**Public Works Committee Meeting**  
**Tuesday, March 5, 2019 5:00 PM**  
**Crete City Hall**  
**243 E 13th Street**  
**Crete, NE 68333**

**CHANGE ORDER REQUEST No. 0004**

## PROPOSAL REQUEST

<b>PROJECT:</b>	Crete Public Library, Community and Technology Center	<b>PROJECT NO.:</b>	17122
<b>CONTRACTOR:</b>	Sampson Construction Co.	<b>DATE:</b>	01/24/2019
<b>REFERENCE:</b>	Detail 4, Sheet A6.5. Roof Edge Change	<b>PR NO.:</b>	#05

4 DETAIL (REFERENCE A/A6.5)  
 1 1/2" = 1'-0"

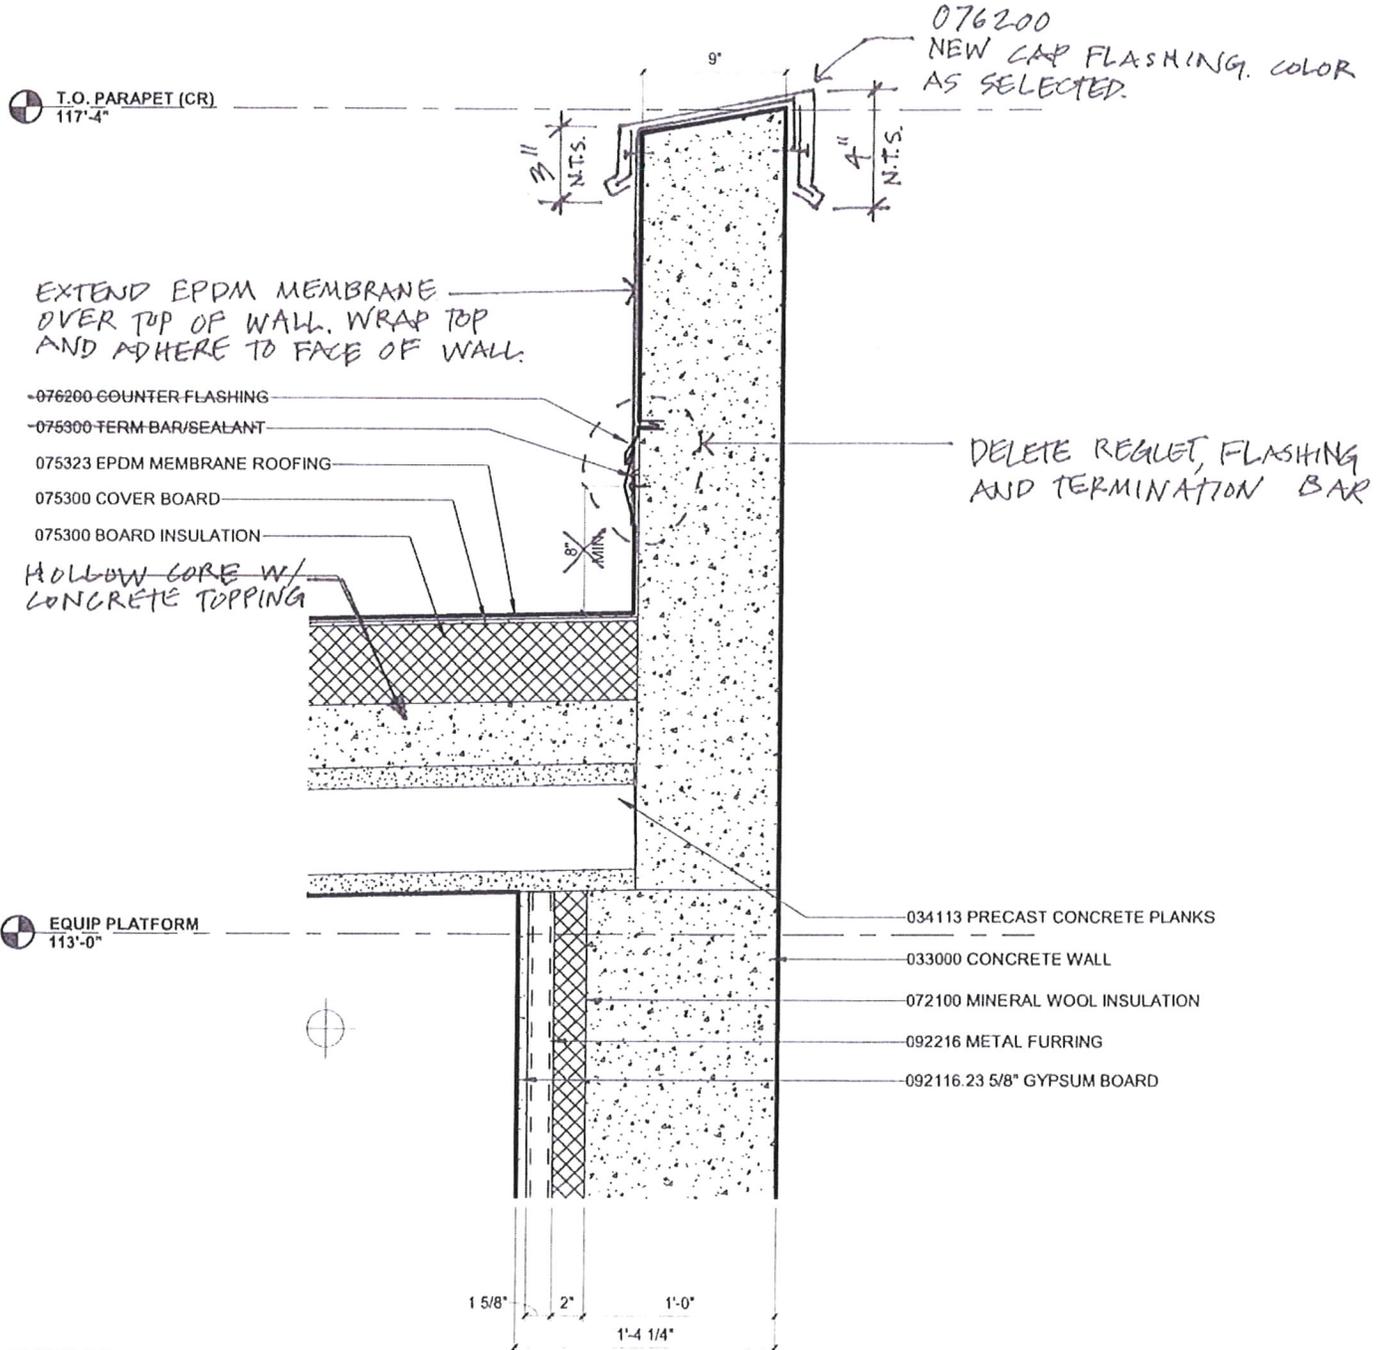
1. Sheet A6.5-Detail 4.
  - a. See attached detail revising the membrane roofing termination at the roof over Community Room 102, Hall 107, Mech 108, Women 106, Men 105, Storage 103 and Food Prep 104.

**DESCRIPTION:** Change in roof parapet condition at storm shelter per PR#5. No plywood included. EPDM will adhere directly to face of cast in place concrete wall.

1 ROOF PLAN

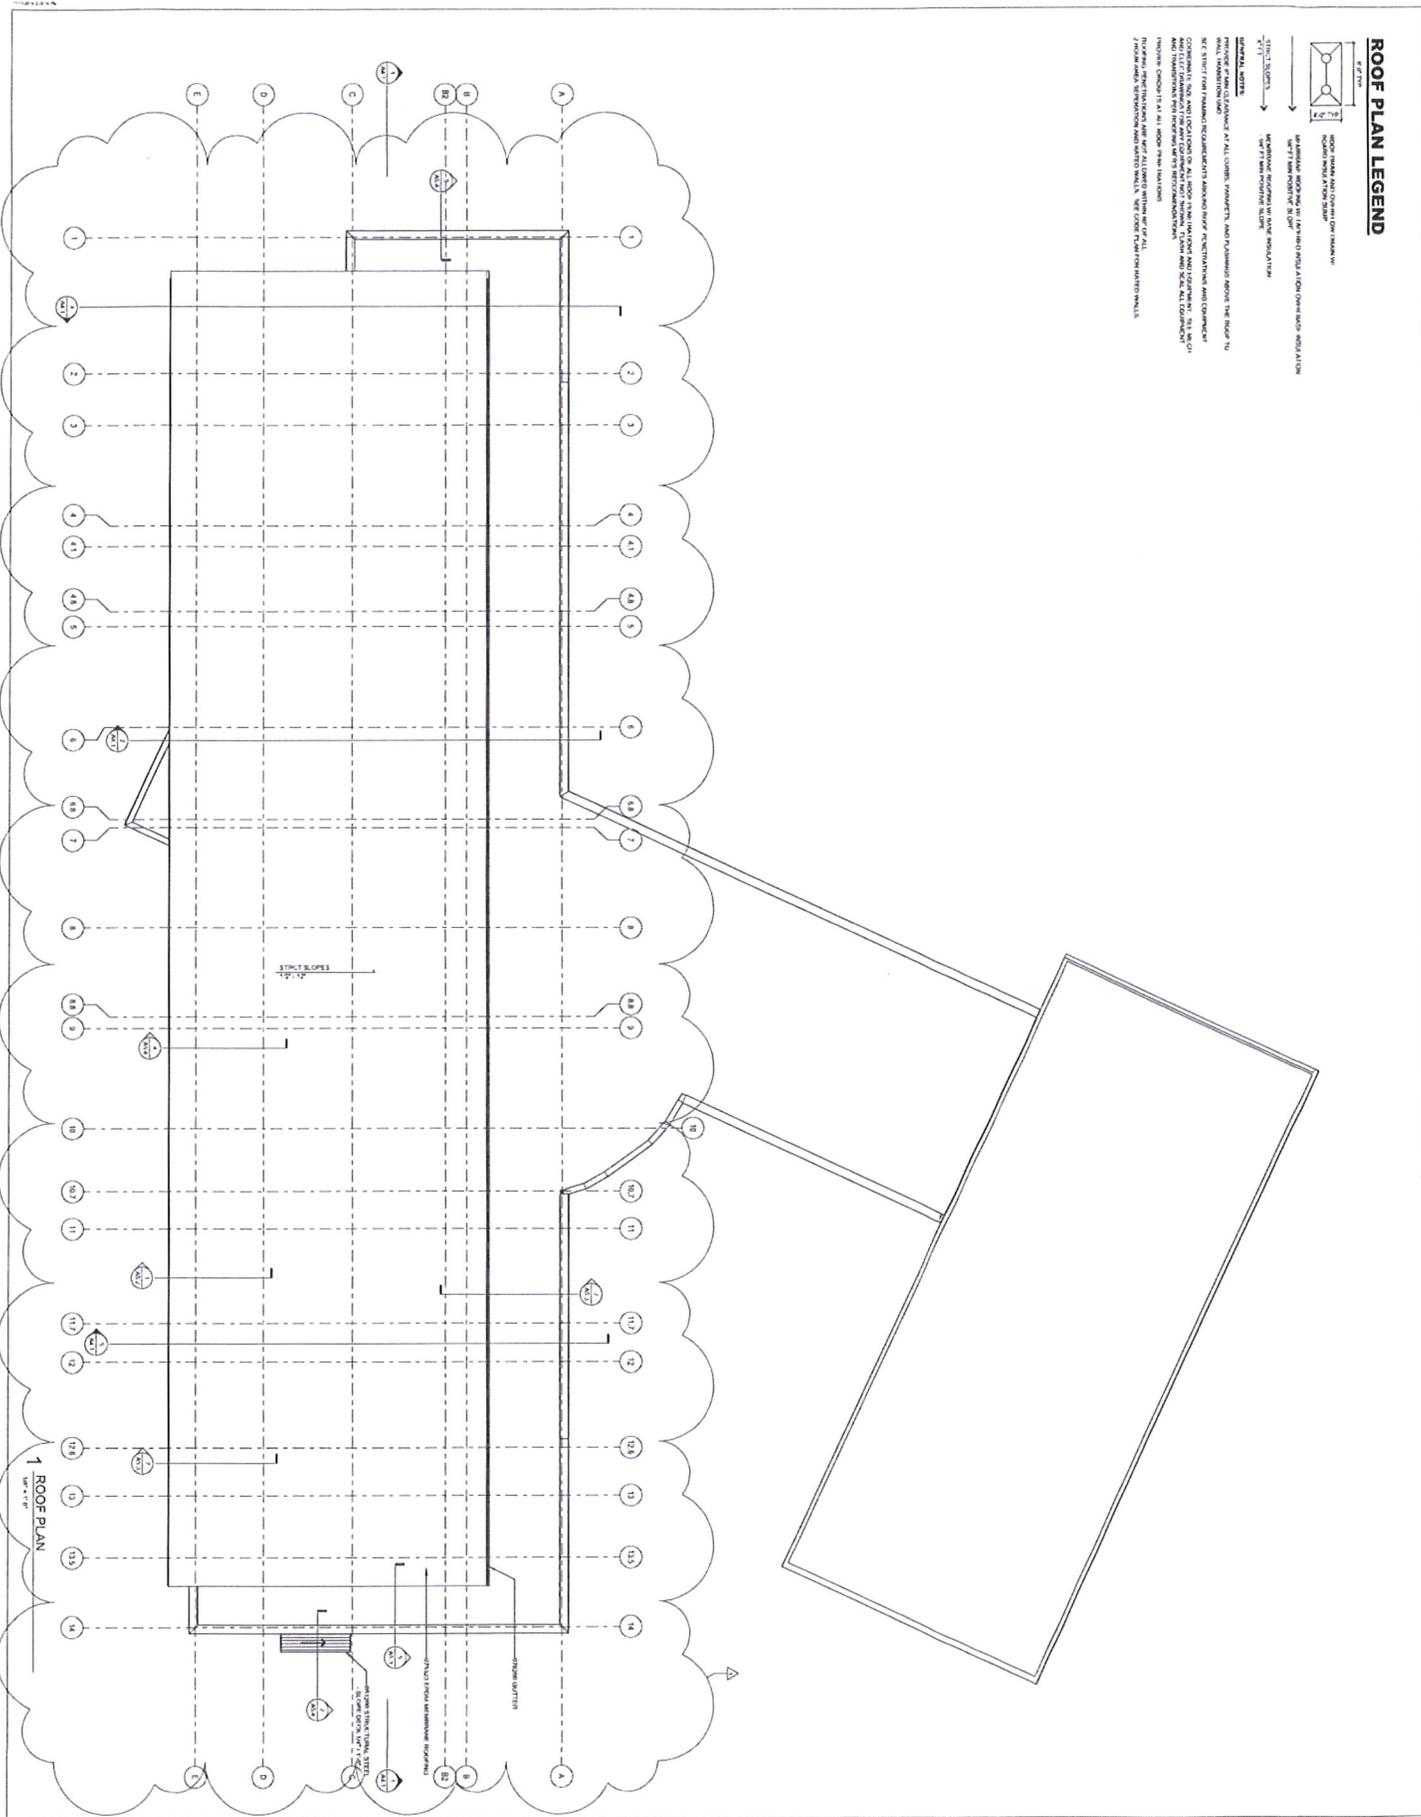
1. Change the sheet metal roofing on the high roof to a white, EPDM membrane roof. Refer to drawings A1.3, A5.3, & A6.3 for additional information.
2. Change the folding glass partition basis of design to Nanawall WD65 i3L1R. Refer to drawing A7.1 for additional information.

10 WALL SECTION - TRASH ENCLOSURE  
1/4\"/>

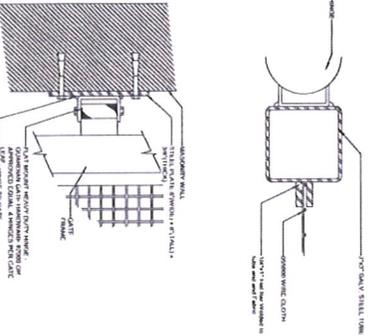
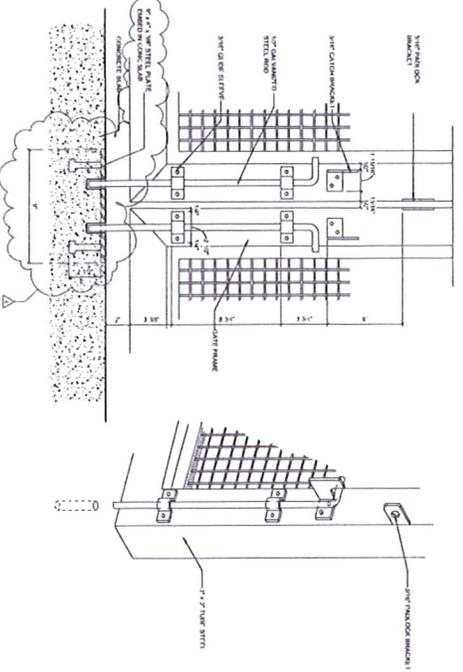
3. Add steel embed plate at trash enclosure gate detail. Refer to attached drawing A1.5 for additional information.
4. Provide additional detailing for reinforcement at roof opening penetrations in the storm shelter. Refer to drawing S5.3 for additional information.
